ADDENDUM #2

ITB No. 260

MODIFICATIONS TO THE THOMAS J. MOYER OHIO JUDICIAL CENTER

Date of Issuance: March 27, 2025

1 11th Floor Plan
1/16" = 1'-0"

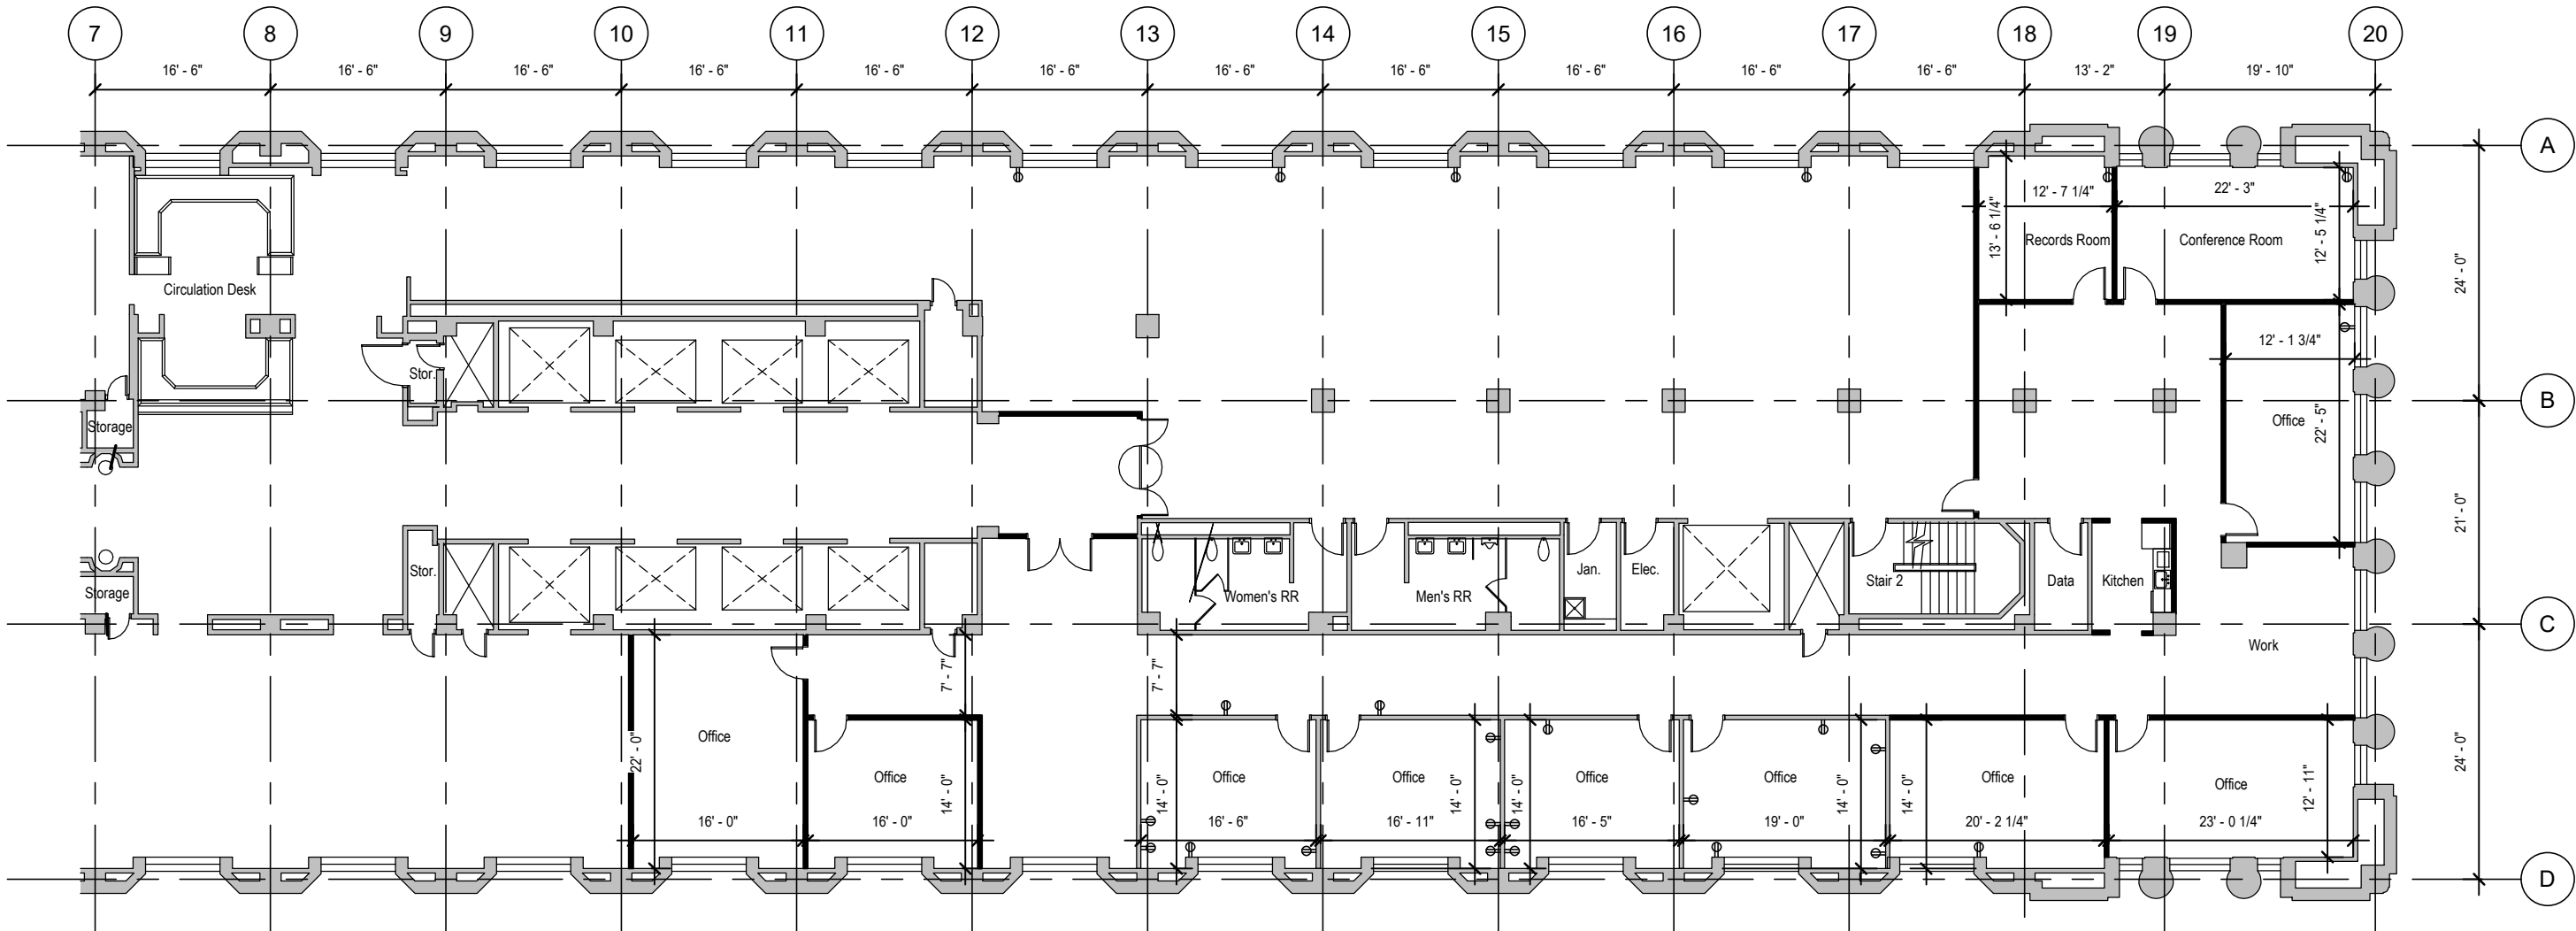
Vendors are advised of the addition of Appendix K, attached to this Addendum, which provides a detailed floor plan to the scope of work and the new walls to be constructed.

Vendors are advised that Appendix A of ITB #260 has been modified, and the newest version is attached to this Addendum. Specifically, the floor dimensions section of Appendix A is amended as follows to match the specifications supplied in Appendix K:

22' x 16' Office
16' x 14' Office
20' 2" x 14' Office
23' x 12' 11" Office
22' 5" x 12' 2" Office
22' 3" x 12' 5" Conference room
13' 6" x 12' 7" Records room
8' x 7' Kitchenette
